Subject: eZ80L925048MODG Module Upgrade

CURRENT VERSION	UPGRADED VERSION
eZ80L925048MODG	eZ80L925148MODG

Changes/Upgrades from the current modules to the replacement modules

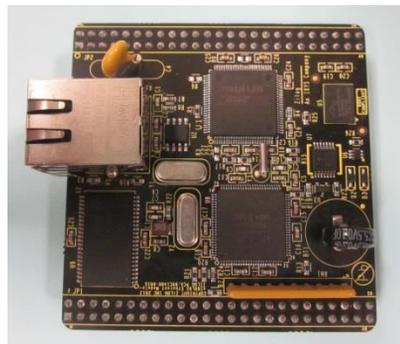
- Off-chip NOR Flash memory increased from 1MB to 8MB
- Battery-backed Real-Time Clock increased from 7mAh to 45mAh
- Zilog ZHX1810 IrDA transceiver no longer available on the new modules
- LEDs are now embedded in the RJ45 connector (please refer to pictures below)
